RECEIPT DATE: 3/4/19**ONSITE SEWAGE DISPOSAL SYSTEM**P 564773APPROVAL DATE: 3/18/19 SEC**PERMIT: CONSTRUCTION**

PROPERTY ADDRESS: 15208 Torino WaySUBDIVISION: Fairlane FarmsLOT: 29

**MEMORANDUM**

**RE: 15208 Torino Way**  
**Fairlane Farms, Lot 29**

SEPTIC PROFILE  
SCALE: 1"=30'

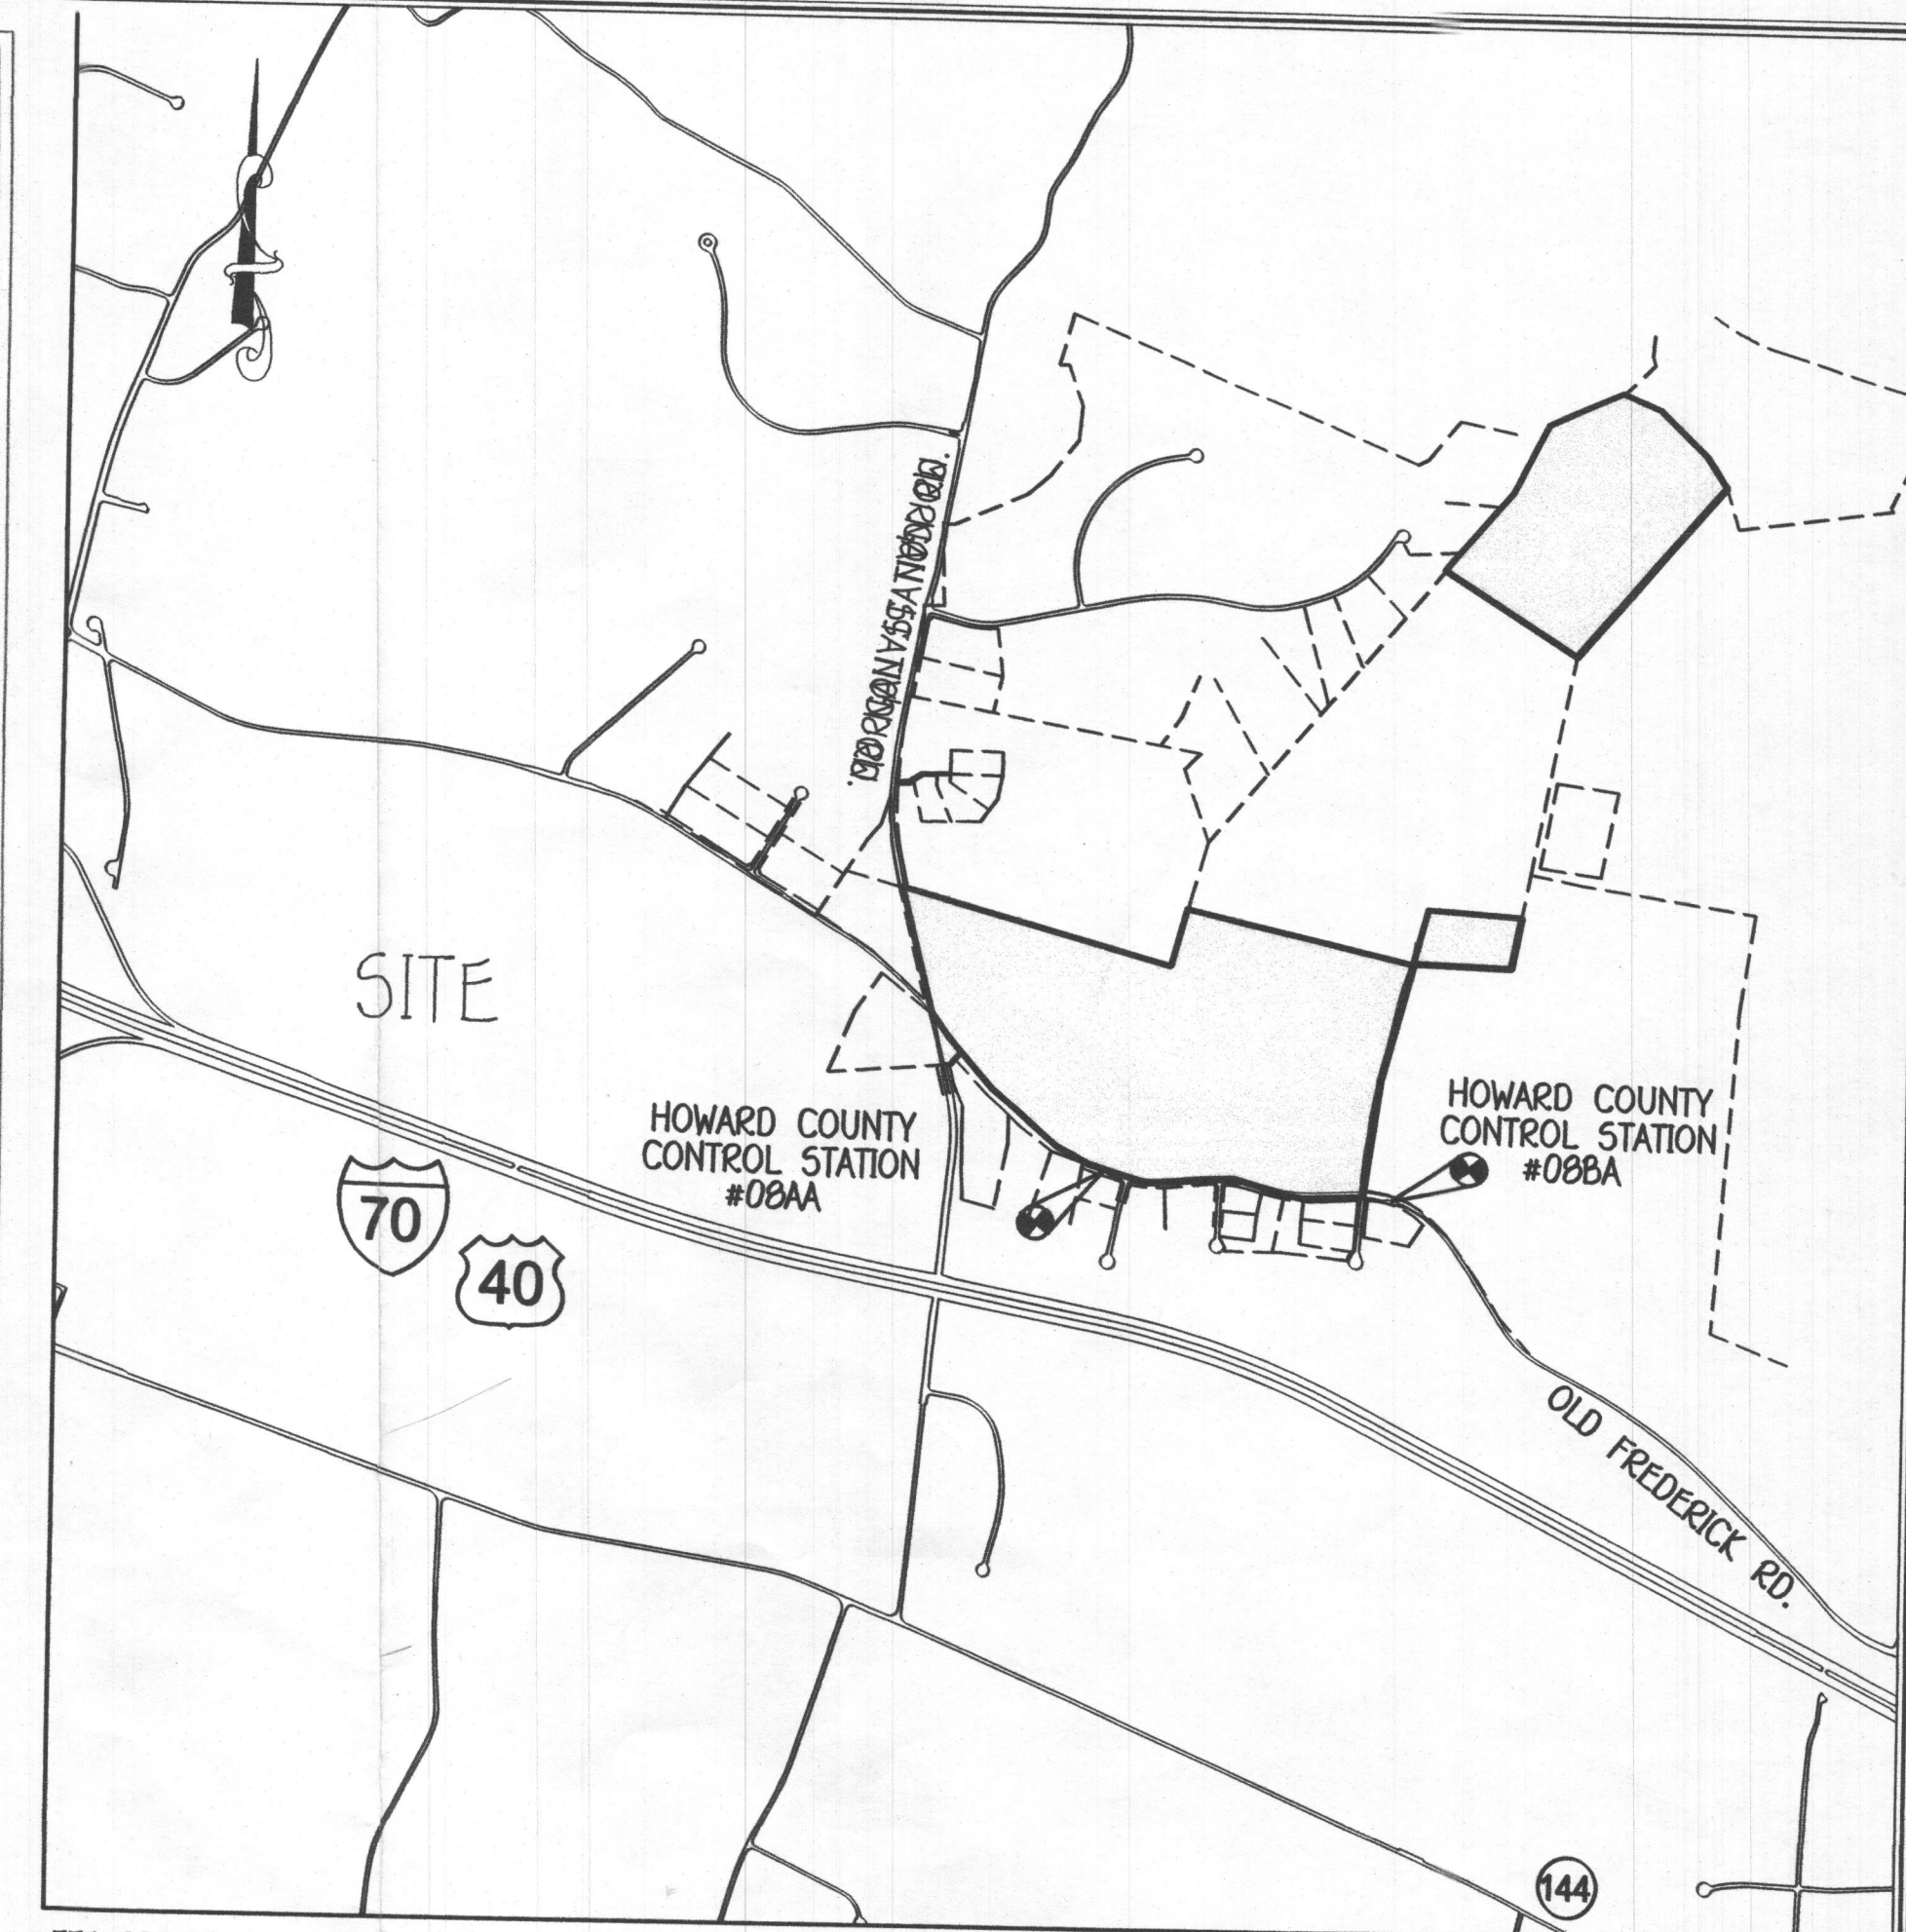
- 1.) Adjust tank location so it isn't within 25 feet of steep slopes (greater than 25 feet).
- 2.) Match elevations in septic profile to the list of elevations on plan. In addition, the invert out of the d-box cannot be lower than the invert into the trench
- 3.) Correct Trench detail depths (i.e. the trench invert is at 1.5 feet but it shows 2 foot of cover).
- 4.) 1<sup>st</sup> replacement coefficient of reduction should be  $(3+2)/3+1+(2 \times 4)$  but 0.417 is correct.  
Show correct #s in the equation.
- 5.) 2<sup>nd</sup> replacement coefficient of reduction should be  $(3+2)/3+1+(2 \times 2.5)$  but 0.55 is correct. Show correct #s in the equation.
